ADDENDUM NO. 1
VILLAGE OF THREE OAKS, MICHIGAN
WATER SYSTEM IMPROVEMENTS PROJECT

CONTRACT A – Water Main & Appurtenances
CONTRACT B – Production Well No. 3
CONTRACT C – Tower Repainting
DECEMBER 1, 2010

Addendum No. 1 to the Plans and Specifications for the Village of Three Oaks Water System Improvements Project, as prepared by Wightman & Associates, Inc. dated October 2010.

EASEMENT CLEARING SKETCH

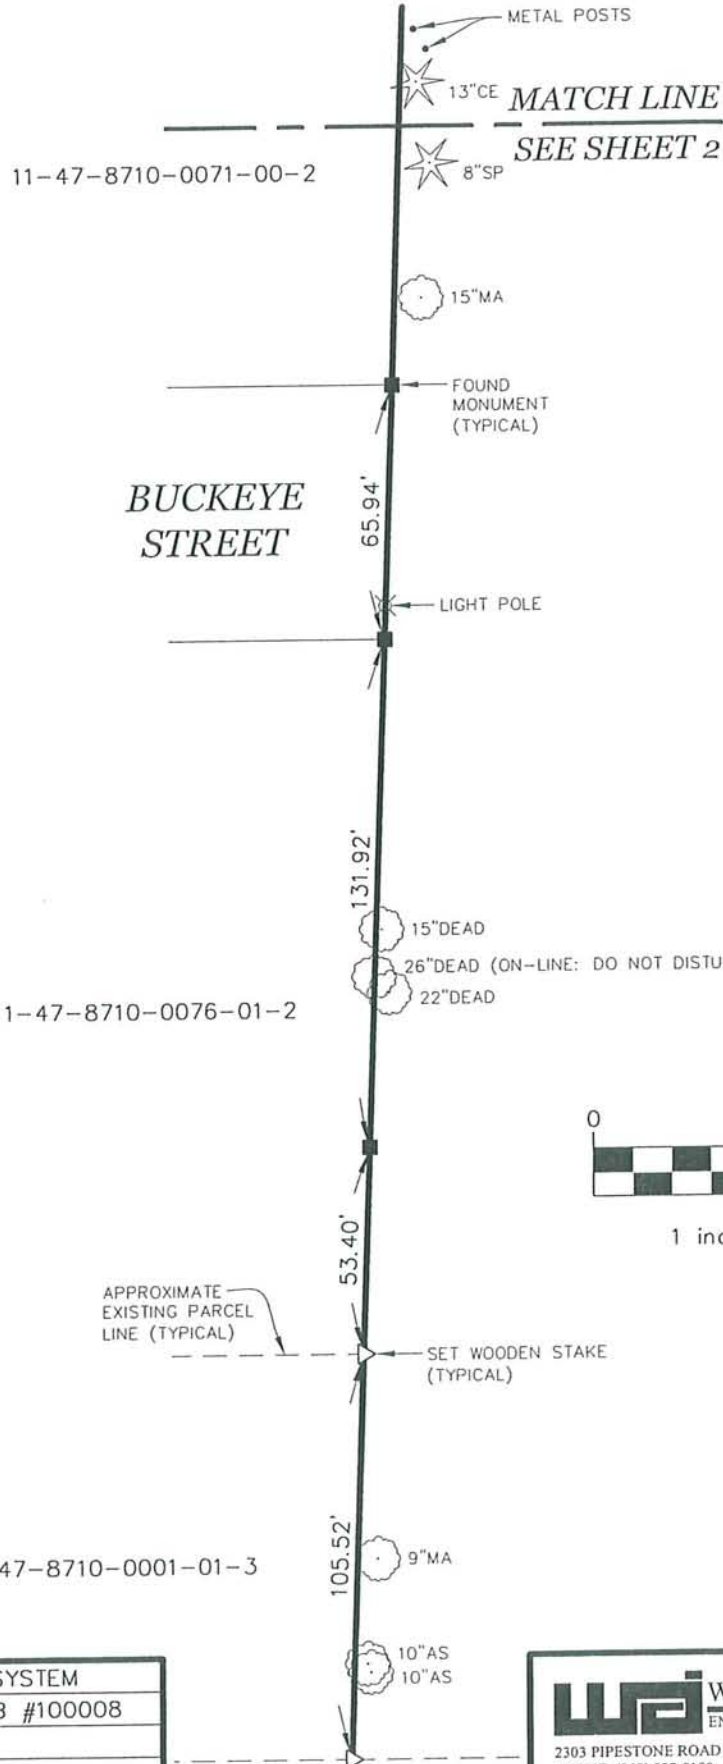
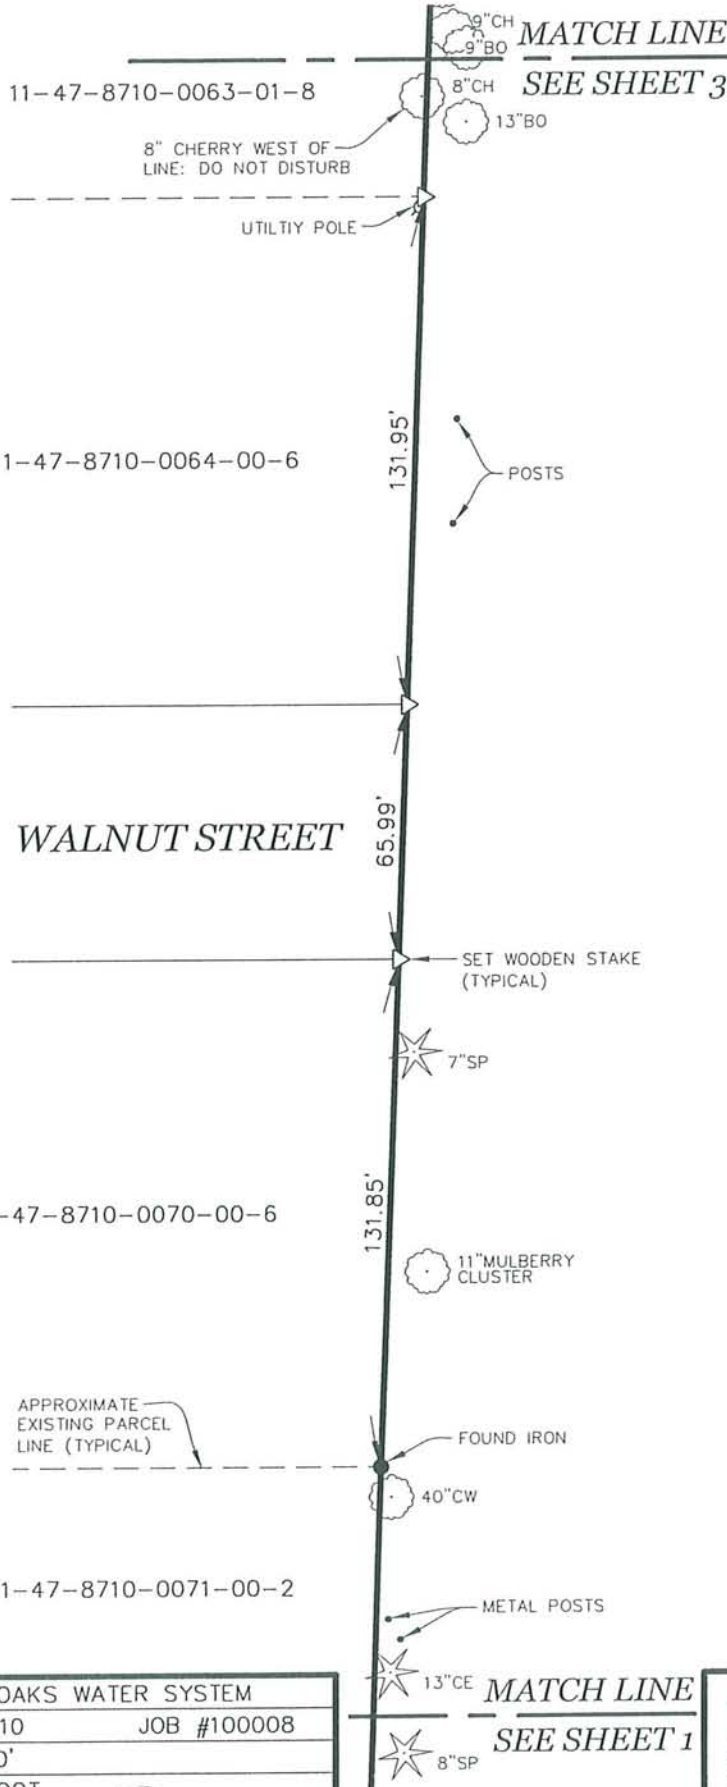
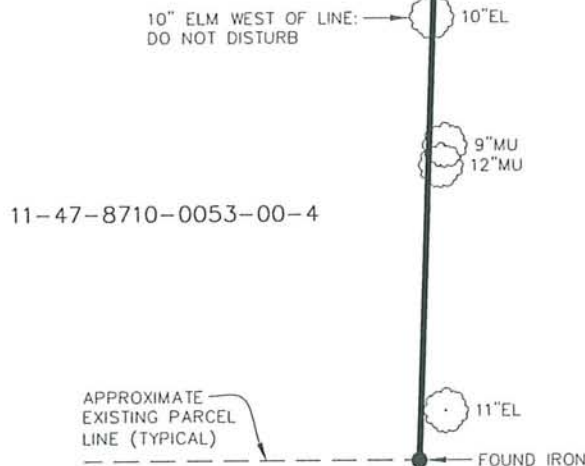
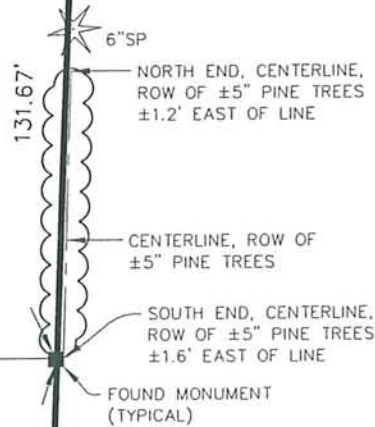
14. The easement area at the east end of Chestnut, Walnut and Buckeye Streets must be cleared of all trees, stumps, and debris, ready for farming. This clearing shall also include the east side of the property line extending 330 feet north of Chestnut Street and 175 feet south of Buckeye Street. The portion of Buckeye Street that extends east outside of the right-of-way should also be saw cut and removed. This work shall be bid as a lump sum under item 34, Easement Clearing. See attached sketch for additional information.
